UNITED STATES PATENT AND TRADEMARK OFFICE

10/789,146

Office Action Summary

DETAILED ACTION

U.S. Patent Mar. 15, 1994 Sheet 12 of 12 5,294,912

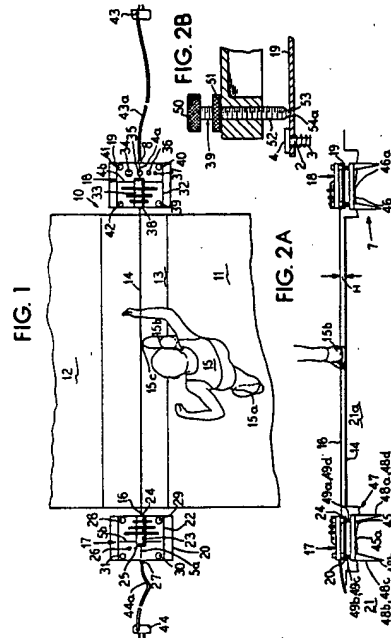
(a) providing a plurality of light beams (704, 707 of figure 16 or 16 of figure 1) from a laser unit (700 of figure 16 or 17 of figure 1);

(b) providing a plurality of light detectors (709, 710 of figure 16) by a detecting device unit (708 of figure 16 or 18 of figure 1) for sensing said plurality of light beams (704, 707 of figure 16);

(d) indicating the presence or absence of each one of said plurality of light beams (704, 707 of figure 16) by the detecting device unit (18 of figure 1 or 708 of figure 16) coupled to a computer (78 of figure 7); and

(e) displaying the position of a foot (697 of figure 16) during a jump takeoff. See figures 1-18.

an infrared light beam emitting device considered to be a laser unit (700 of figure 16 or 17 of figure 1) for emitting a plurality of infrared light beams (704, 707 of figure 16);

an infrared light beam detecting device considered to be a detecting unit a detecting device unit (708 of figure 16 or 18 of figure 1) for sensing the presence of said plurality of light beams (704, 707 of figure 16);

a displaying means (figure 7) considered to be a LCD display (79 of figure 7) coupled to coupled to a computer (78 of figure 7) for indicating the presence or absence of each one of said plurality of light beams (704, 707 of figure 16);

a memory considered to be a power supply switch (67 of figure 6A) coupled to a low battery detector circuit (72 of figure 6A), LED flasher circuit (71 of figure 6A) and coupled to an auto shut-down circuit (70 of figure 6A) for storing the status of the plurality of infrared light beams (704, 707 of figure 16) at the moment of takeoff of the foot 697 of figure 16); and

a recall switch (34, 35, 36, 37 of figure 1 and col. 4 lines 34-55) of the detecting unit (18 of figure 1) coupled to computer (78 of figure 7) for recalling and displaying the status on the display means, wherein the foot position of a foot (697 of figure 16) during a jump takeoff. See figures 1-18.

U.S. Patent Mar. 15, 1994 Sheet 1 of 12 5,294,912

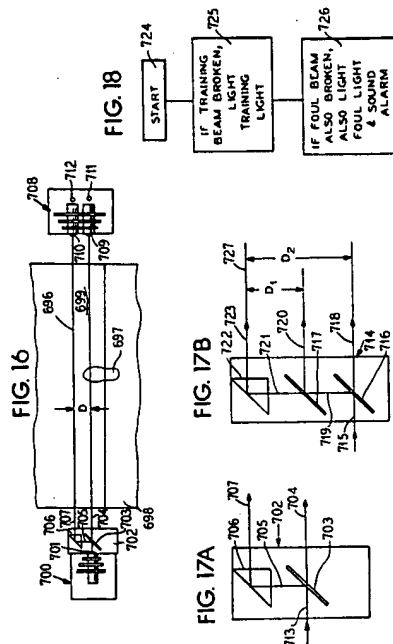
(c) enabling at least one light beam of said plurality of light beams at a time by an LED indicator and a off/on switch (25, 26 of figure 1 and col.4 lines 22-30) of the laser unit (17 of figure 1), enabling at least one light detector (18 of figure 1) corresponding to said at least one light beam (16 of figure 1);

Regarding claim 6; Bednarz et al discloses recalling said presence or absence of each of said plurality of light beams from said memory by a recall switch activation (34, 35, 36, 37 of figure 1 and col.4 lines 34-55).
